RE: JMC Project 23050  
 Majidi Subdivision  
 21 Whippoorwill Road  
 Town of North Castle, NY  
 Tax Lot 107.04-1-11

**Response to Comment Memoranda Received from the Planning Department and KSCJ Consulting**

ZONING COMPLIANCE PLAN  
MAJIDI SUBDIVISION  
21 WHIPPOORWILL ROAD  
NORTH CASTLE, NY 10504

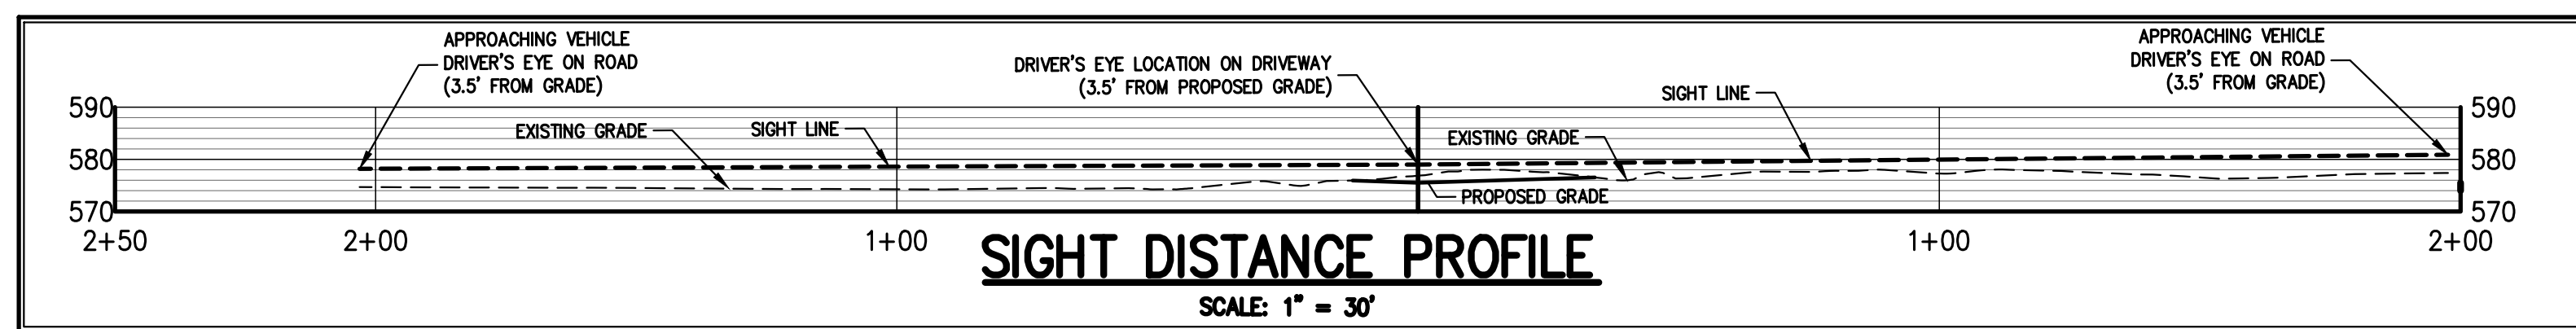
*The plat should be revised to demonstrate the average Lot Width and Lot Depth for all proposed lots utilizing an exhibit depicting how Lot Width and Lot Depth were calculated. Typically, this exhibit depicts measurements every 20-30 feet and the average calculated based upon the measurements.*

**The requested dimensions have been added to the Drawing C-020 “Zoning Compliance Plan.”**

**INTEGRATED PLOT PLAN**  
MAJIDI SUBDIVISION  
21 WHIPPOORWILL ROAD  
NORTH CASTLE, NY 10504

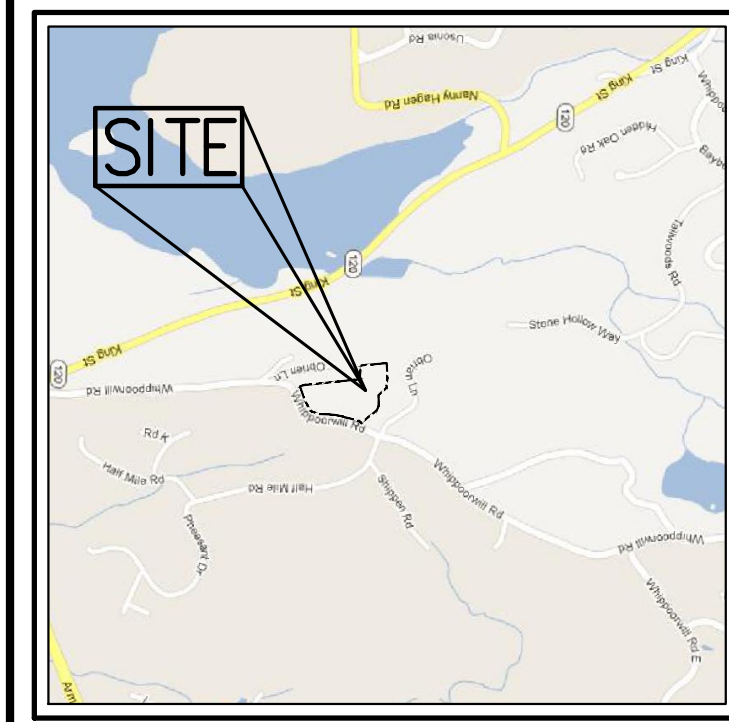
*The applicant shall provide sight distance profiles for the proposed driveway demonstrating adequate sight lines for a minimum distance of 200 feet in each direction, as required by the Town Code. The plans shall illustrate any proposed site improvements required to achieve the sight distance.*

*Sight lines to the south viewing oncoming traffic from the south, from the proposed driveway and sight lines for vehicles traveling from the south viewing vehicles turning into the proposed driveway from the south is restricted by vegetation and grades along the property frontage. The applicant is using a driver's eye elevation of 580 feet; however, the actual elevation appears closer to 578.5 feet. The applicant should prepare a detailed plan of how safe sight lines of 200 feet can be obtained.*

*The applicant should examine relocating the driveway curb cut further to the north in the vicinity of the proposed northern property line, where sight lines could likely be obtained with much less clearing and grading to the south.*

**The driveway has been shifted to the north as recommended and adjusted to minimize any required clearing and grading to achieve the required stopping sight distance.**

**Drawing C-100, "Integrated Plot Plan", illustrates in plan view the required 200 foot sight distance in both directions from the site driveway per Town Code Section 355-59.D. Per Section 3.2.6.1 of the American Association of State Highway and Transportation Officials (AASHTO) publication, "A Policy on Geometric Design of Highways and Streets", latest edition, "for all sight distance calculations for passenger vehicles, the height of the driver's eye is considered to be 3.50 ft [1.50 m] above the road surface."**

**A "Sight Distance Profile" view is also provided on Drawing C-100, utilizing a driver's eye height of 3.5 feet for both the vehicle traveling along Whippoorwill Road and the vehicle at the proposed site driveway. The profile view illustrates that the existing and proposed grades do not interfere with the sight lines to/from the proposed driveway at the required 200 foot sight distance, and the drivers of the vehicles on either side of the sight line will be able to have a similar view. AASHTO additionally describes the average vehicle height to be 4.25 feet, meaning that the vehicle in the proposed site driveway and the vehicle traveling along Whippoorwill Road will be visible at a height of 0.75 feet at the sight line distance, as illustrated in the "Sight Distance Profile".**

CONCEPTUAL GRADING AND UTILITIES PLAN  
MAJIDI SUBDIVISION  
21 WHIPPOORWILL ROAD  
NORTH CASTLE, NY 10504

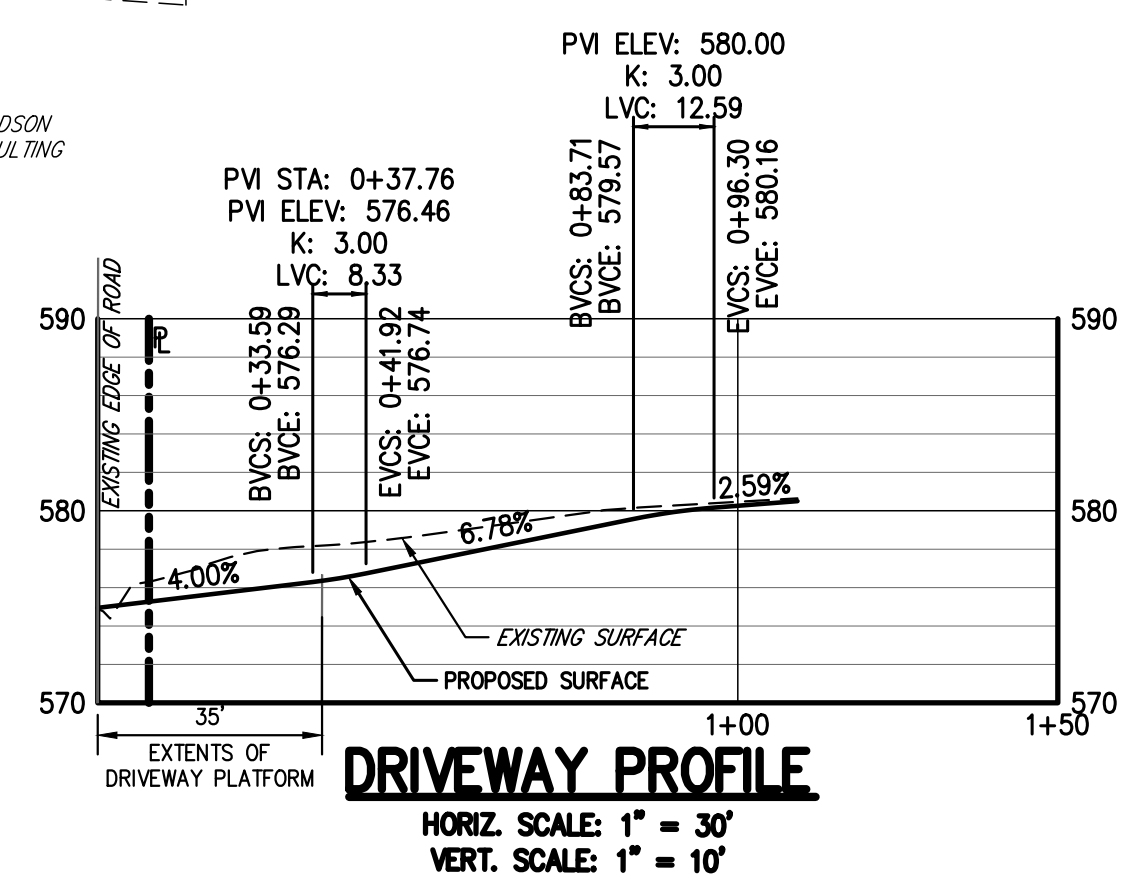
*The applicant has submitted a driveway profile and site grading. The driveway profile should be revised to reflect a maximum entrance platform grade of 4%.*

**The driveway grading has been revised and a maximum platform grade of 4% has been provided, as illustrated on Drawing C-200 “Conceptual Grading and Utilities Plan”.**
